Contract #: 04-0120F4Cty: SF/ALA Rte: 80 PM: 13.2/13.9File #: 69.25B**QUALITY ASSURANCE -- NON-CONFORMANCE REPORT****Location:** Changxing Island, Shanghai, PRC**Report No:** NCR-000367**Prime Contractor:** American Bridge/Fluor Enterprises, a JV**Date:** 27-Jul-2009**Submitting Contractor:** Zhenhua Port Machinery Company, Ltd (ZPMC), Changxing Island**NCR #:** ZPMC-0341**Type of problem:**

Reference Description: Base Metal Distortion OBG Segment 7BW**Description of Non-Conformance:**

Job Name: SAS Superstructure

Subject: NCR No. ZPMC-0341

焊缝返修位置示意图:

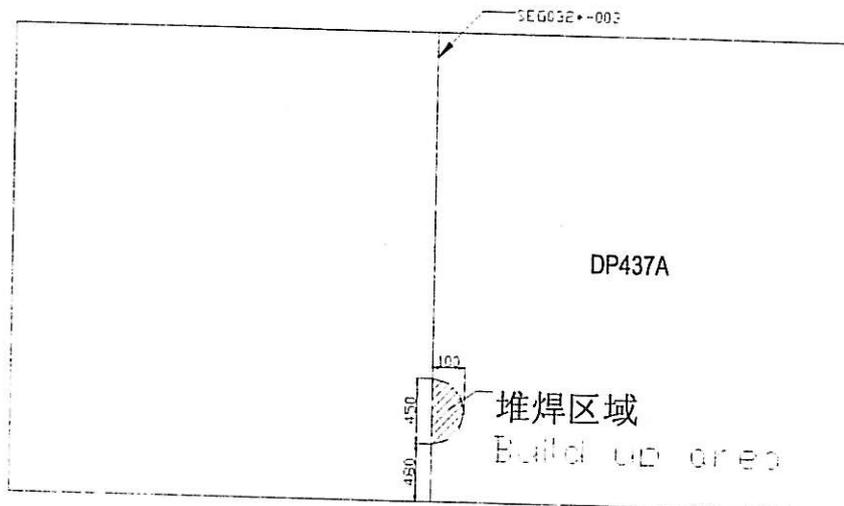
完工报验时发现, 顶板对接焊缝SEG032*-003有局部变形, 现场已经将低洼处做堆焊处理, 具体位置见下图!

After final inspection, deck plate butt weld (SEG032*-003) was part distortion, and it build up the low-lying area, the detail see the following draft.

1. 准备一个正确的接头型式，具体参照相应的返修WPS;
 2. 将碳刨区域打磨光滑，开始和结束的接头交错布置;
 3. 对修补区域进行VT与MT检测;
 4. 根据批准的返修焊接工艺规程 (WPS) 进行预热及焊接;
 5. 将修补区域打磨与母材或相邻焊缝平齐;
 6. 对修补区域作100%VT与MT检测;
-
1. Prepare excavation according to the approved repair WPS.
 2. Grind the gouged area to a smooth and shiny finish, with tapered ends, to ensure staggered starts and stops.
 3. VT and MT the repair area.
 4. Preheat and weld according to the relevant repair WPS.
 5. Grind the repaired area flush with base metal or the adjacent weld.
 6. Perform VT and MT over 100% of the repair area.

焊缝返修位置示意图:

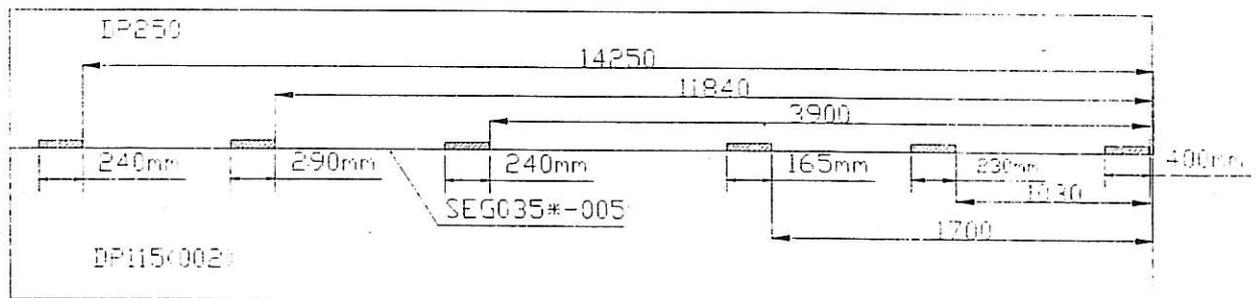
经检查发现7BW顶板三拼后, DP250与DP115(002)焊接后有六处变形错位, 其中最大变形量为10mm, 涉及焊缝为SEG035*-005, 具体位置及长度如下图所示:

After inspection 7BW DP250 and DP115(002) deck plate splice, it was six position misalignment, maximum 10mm, weld No.: SEG035*-005, the detail see the following draft.

1. 采用火焰切割的方法从顶板对接错边位置割开长度L, L根据现场错边情况而定;
 2. 根据批准的WPS准备焊接接头型式;
 3. 采用工艺卡码及千斤顶调整顶板错边量, 并进行定位;
 4. 焊接前对坡口进行VT与MT检测确认无缺陷存在;
 5. 根据批准的WPS进行预热及焊接顶板焊缝;
 6. 将返修处焊缝打磨与母材或周边焊缝平齐;
 7. 焊后根据图纸要求对焊缝作NDT检测;
-
1. Cut the weld between deck plates with a certain length L which begin with misalignment emerging by flame cutting, L is conformed by actual condition.
 2. Prepare the excavation according to the approved WPS.
 3. Adjust the misalignment of deck plates to meet the tolerance by assistant support and jack, and tack weld.
 4. Perform VT and MT inspection to the groove to ensure no defects exist prior to welding.
 5. Preheat and weld the butt joint between deck plates according to the approved WPS.
 6. Grind the welds flush to the adjacent welds or base metal.
 7. Perform NDT according to the shop drawings.
